North Little Rock Planning Commission
April 9, 2024 - Agenda / Public Hearing 4:00 PM
City Council Chambers – 300 Main Street, NLR, AR 72114

**North Little Rock Planning Commission
Minute Summary
March 12, 2024**

Item #1

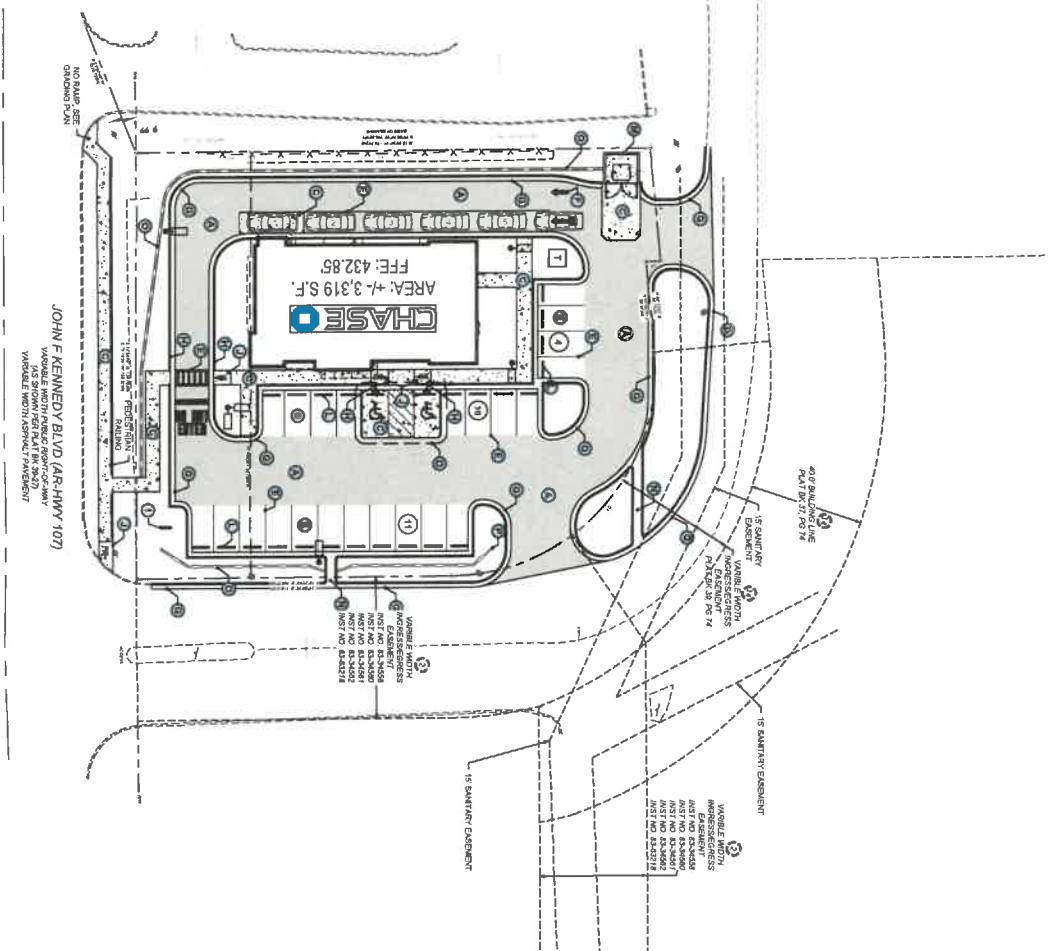
- g. Plant materials appear to be in conflict with the retaining wall on the east and south perimeters of the property. Verify allotted planting space is conducive for trees and shrubs.

9. Meet the requirements of NLR Wastewater, including:
 - a. Please add the existing 8" sanitary sewer main and a 15' sanitary sewer easement. See attached map.

PLAT OF
 LOT 3R & 4R, BLOCK 25,
 MILITARY HEIGHTS RENEWAL ADDITION
 PULASKI COUNTY
 NORTH LITTLE ROCK, ARKANSAS
 ASSIGNED MAP NO. 11-25274
 SHEET NO. 1

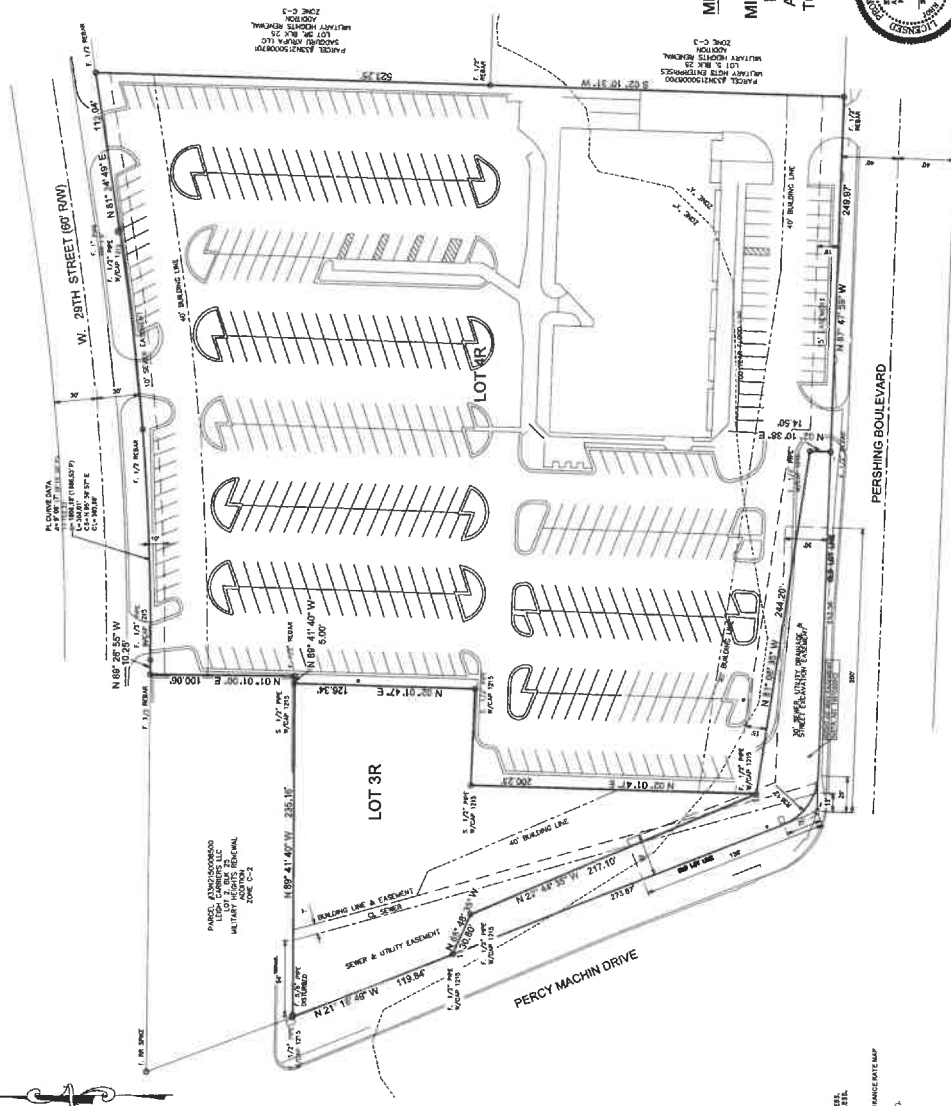
8. Meet the requirements of CAW.
 - a. There is an existing 8" water main on the south side of Lot 4R. Provide an easement for those water utilities on the plat.

9. Meet the requirements of NLR Wastewater, including:
 - a. For the northern section of the existing sewer line on Lot 3R that is outside of the 40' building line please provide a sanitary sewer easement from the 7' offset back to building line. Please see attached drawing.

SITE PLAN REVIEW
 LOT 15,
 COUNTS MASSIE INDUSTRIAL PARK,
 NORTH LITTLE ROCK, CLASCO COUNTY,
 MISSISSIPPI

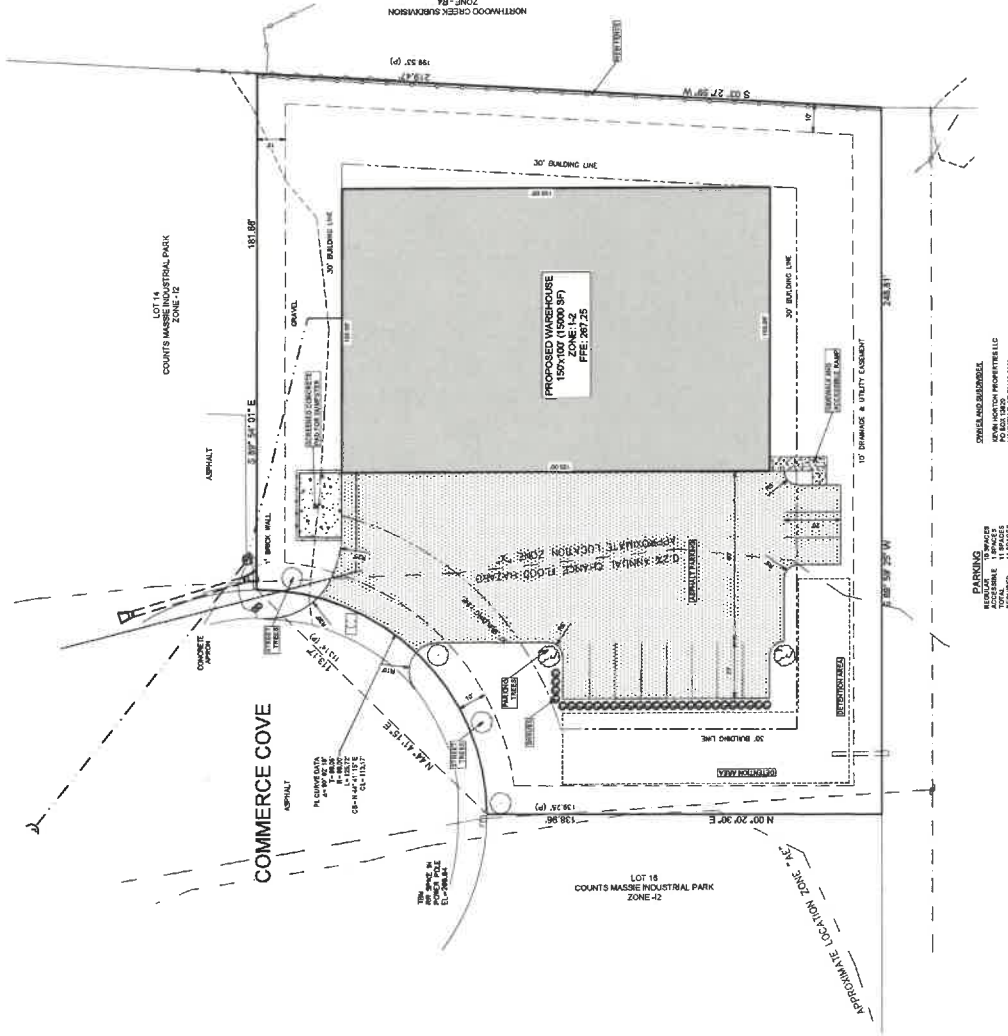
- b. Provide additional shrubs adjacent to the south parking bays.
 - f. Ground cover shall be selected from Section 7.5 of the North Little Rock zoning code. Plant materials / turf from Table J, or mulch of shredded bark or stone shall be applied in all landscaped areas.

- a. Provide an approved fire protection plan.
 - b. Meet the requirements of the 2021 Arkansas Fire Prevention Code including:
 - i. Group S-1 storage facilities with fire areas exceeding 12,000 square feet shall be equipped with an automatic fire sprinkler system. (Volume 2 Section 903.2.9)

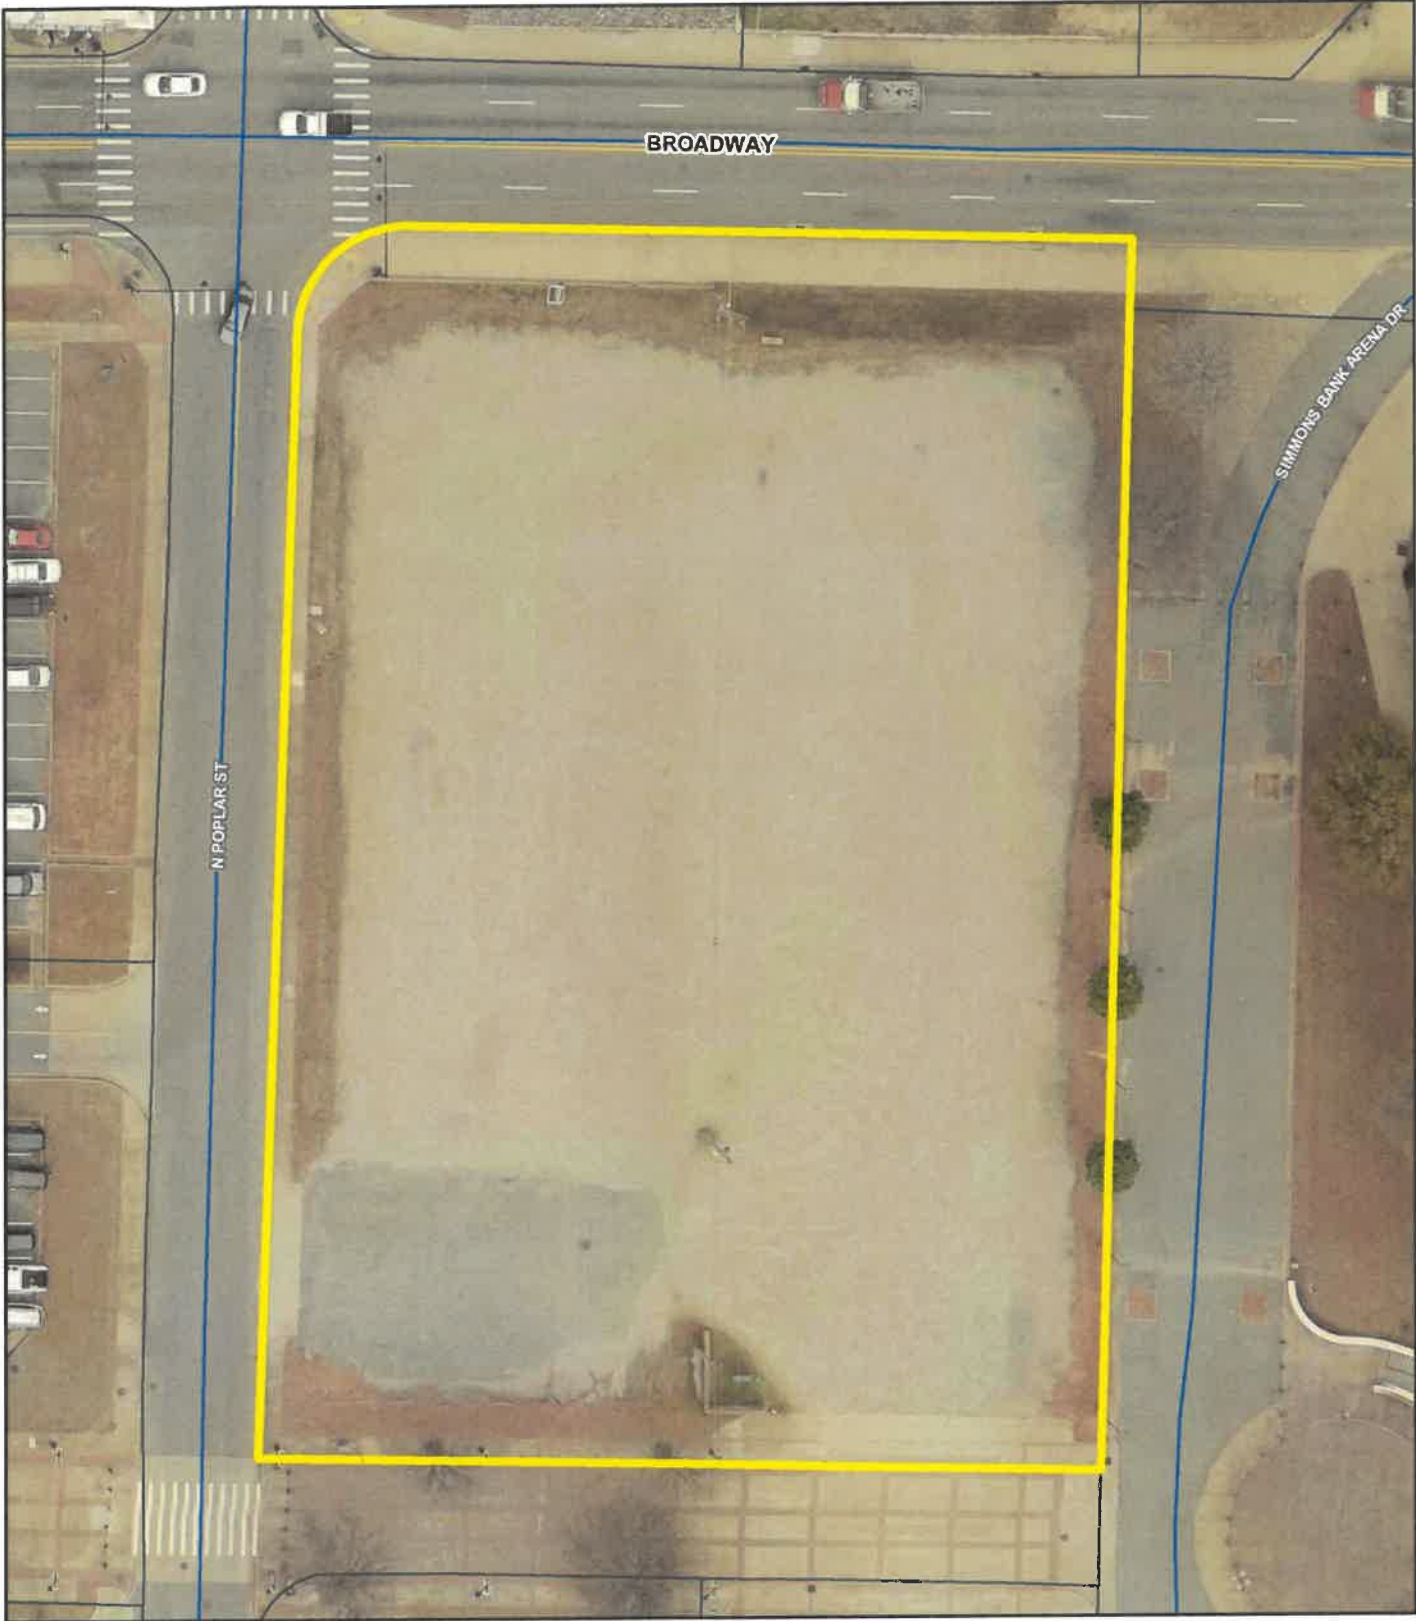
The landscape strip located along Poplar Street is indicated within the public right of way. The plan does not include a landscape strip along E Broadway. The plan also does not include a landscape strip along the southern perimeter of the proposed surface parking lot located on Lot 4A. Street trees are not included on the plan as typically required. A minimum of 9 trees are required along Poplar Street on Lot 4A and a minimum of 3 trees are required along Poplar Street on Lot 6A. A total of 8 parking lot trees are required on Lot 4A.

The plan indicates a Porte-cochère constructed over the property line between Lots 4A and 5A. Typically buildings are not permitted to encroach onto adjacent lots. Within the C6 zoning district setbacks are allowed at 0-feet on the front and side yards. The rear yard setback is to be 10-feet. For the hotel, with the front being E Broadway, the front yard is indicated at 0-feet, the eastern side 10-feet and the rear yard setback at 4-feet. Lots 6A and 6B are indicated along E 2nd Street, the front yard, is indicated ranging from 0.18-feet to 0.02-feet. The northern property line, adjacent to the hotel and proposed surface parking lot, the rear yard are indicated at 5.23-feet.

Staff has a number of concerns related to the proposed development. Staff is not supportive of the applicant's request.
